HISTORIC AND DESIGN REVIEW COMMISSION

HDRC CASE NO: 2018-584
ADDRESS: 107 PASO HONDO
LEGAL DESCRIPTION: NCB 591 BLK 4 LOT 14
ZONING: RM-4, H
CITY COUNCIL DIST.: 2
DISTRICT: Dignowity Hill Historic District
APPLICANT: Cotton Estes/High Cotton Architects
OWNER: Anthony Corbin, William Carson
TYPE OF WORK: Modifications to the original roof form, window replacement
APPLICATION RECEIVED: November 16, 2018
60-DAY REVIEW: January 15, 2019
REQUEST:

**Historic and Design Review Commission
Design Review Committee
Report & Recommendation**

PROPOSED ROOF PLAN

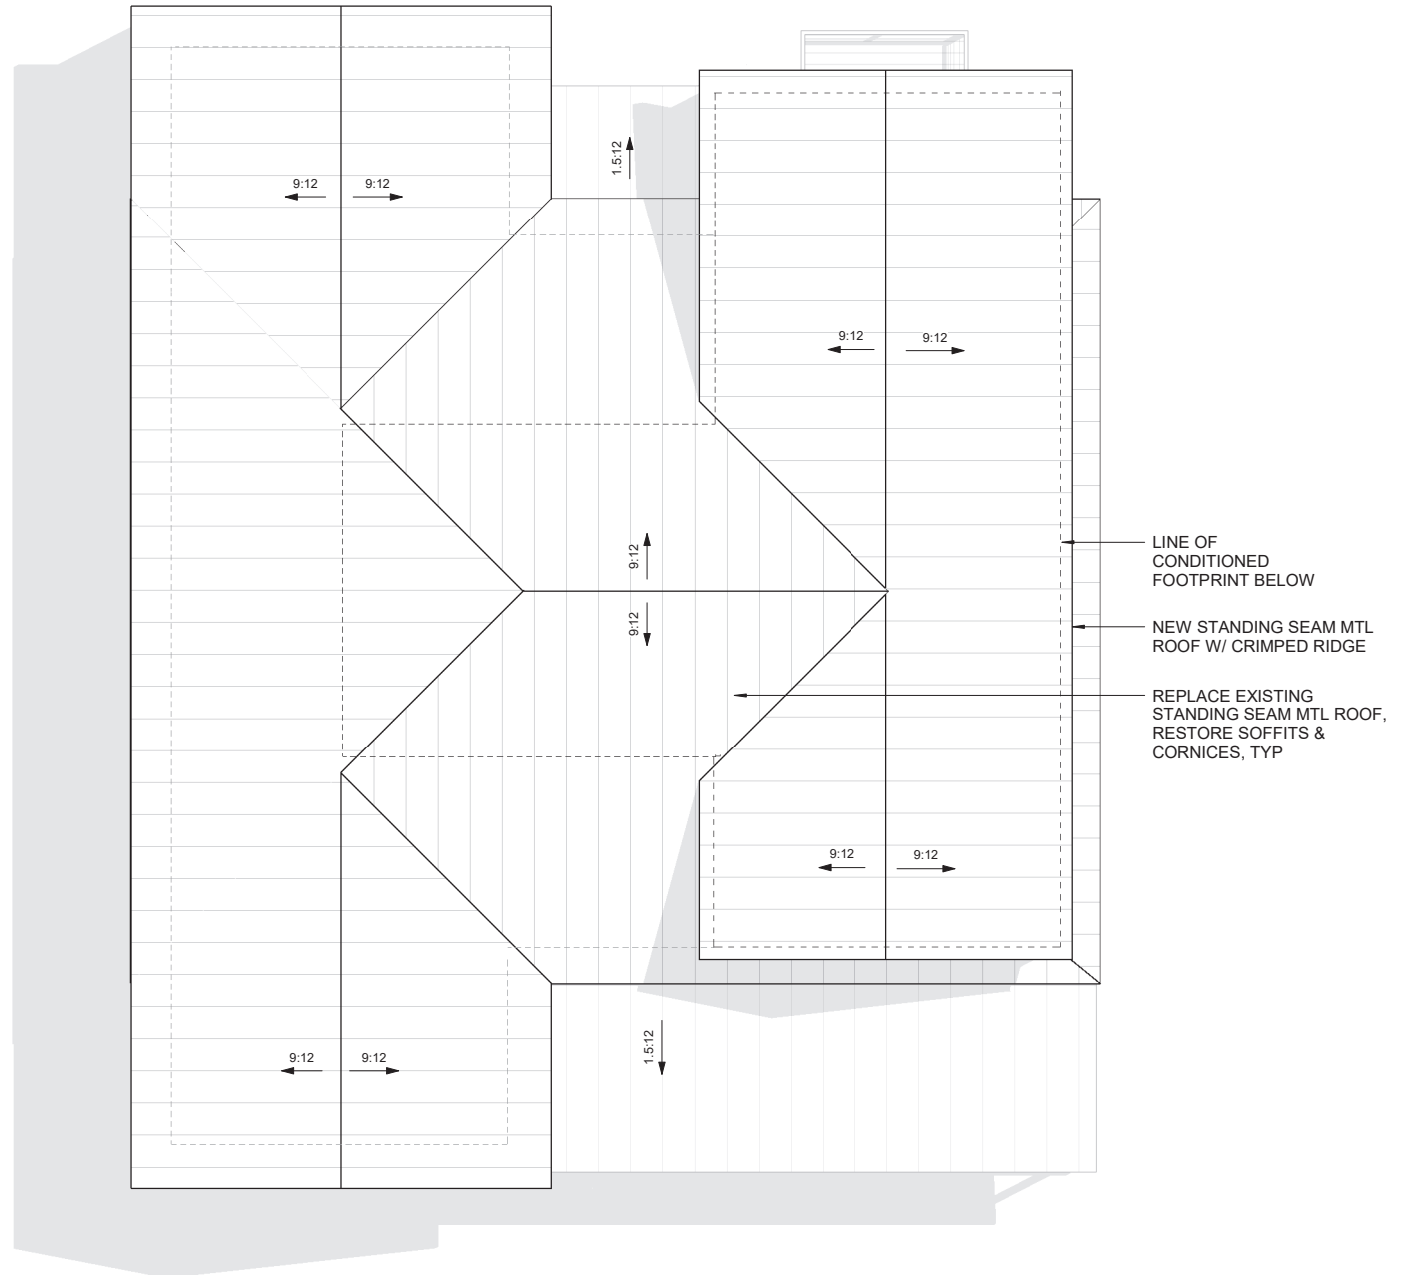
- h. ROOF FORM – The applicant has proposed for the addition to feature both a front and rear facing gabled roof. The proposed roof form will feature a side roof slop that will modify the historic structure's hipped roof. The Guidelines for Additions 1.B.iii. notes that dormers should be compatible in size, scale, proportion, placement and detail with the style of the house and should be located on non-primary facades. Staff finds that the proposed dormer addition would be more appropriate located on the rear façade. Additionally, the historic structure's roof form is character defining to the historic structure. The proposed addition alters the historic roof form in a manner that is inconsistent with the Guidelines.

- k. ARCHITECTURAL DETAILS – Staff finds that the proposed dormer addition would be most appropriate located on the rear façade where it would preserve the hipped roof form as viewed from the front, primary façade.

Staff does not recommend conceptual approval of request item #5, the construction of a dormer addition on the front façade. Staff recommends that the applicant retain the form of the original roof structure and construct additions to the rear of the historic structure.

PROPOSED SOUTH ELEVATION

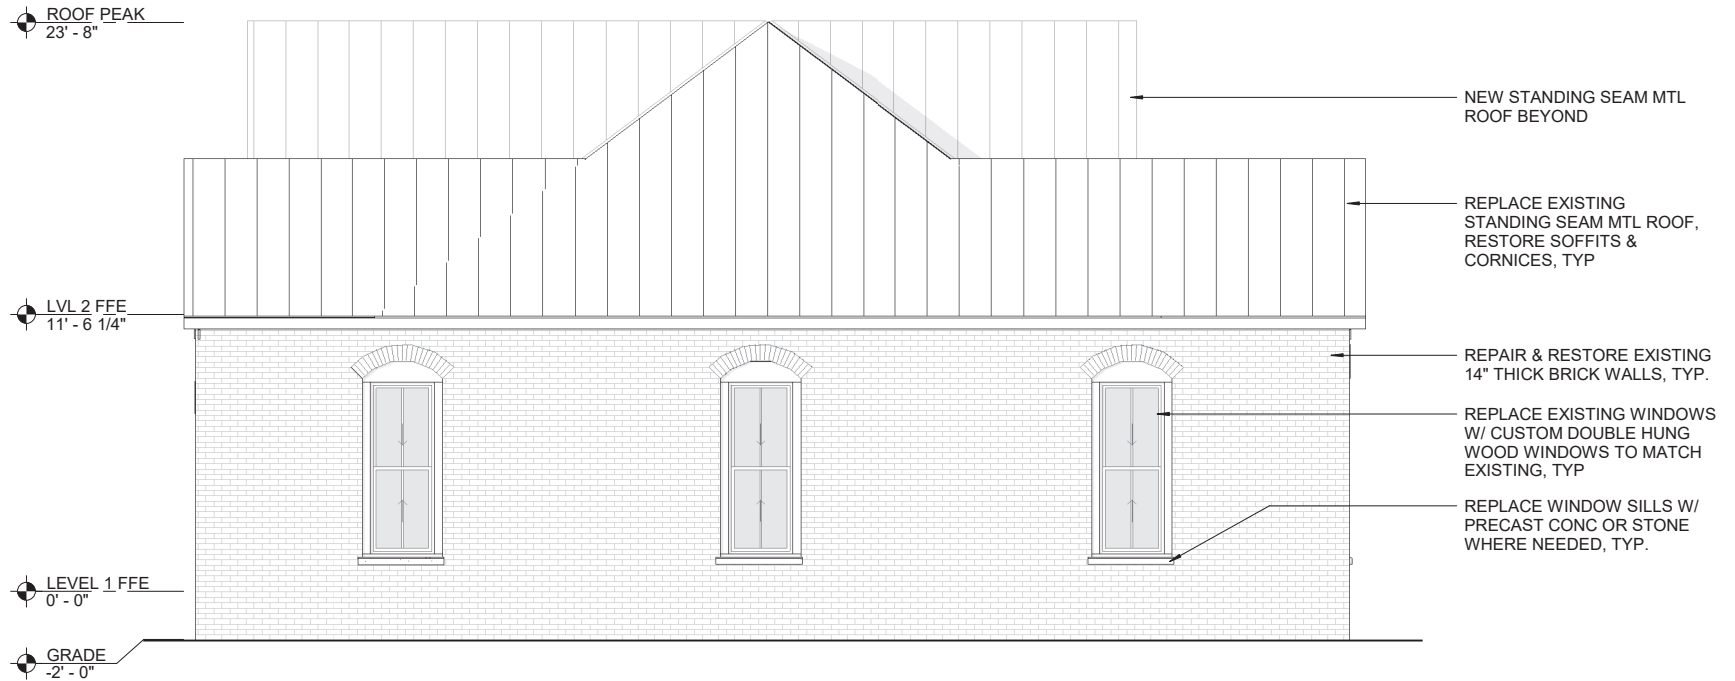
- g. SECOND STORY ADDITION – The applicant has proposed to construct a second story addition that will result in the modifications to the original roof form of the historic structure as well as a front facing dormer. The Guidelines for Additions 1.A. states that additions should be sited to minimize visual impact from the public right of way, should be designed to be in keeping with the historic context of the block, should utilize a similar roof form and should feature a transition between the old and the new. The proposed addition is not consistent with the Guidelines, primarily through the addition of the front facing dormer.
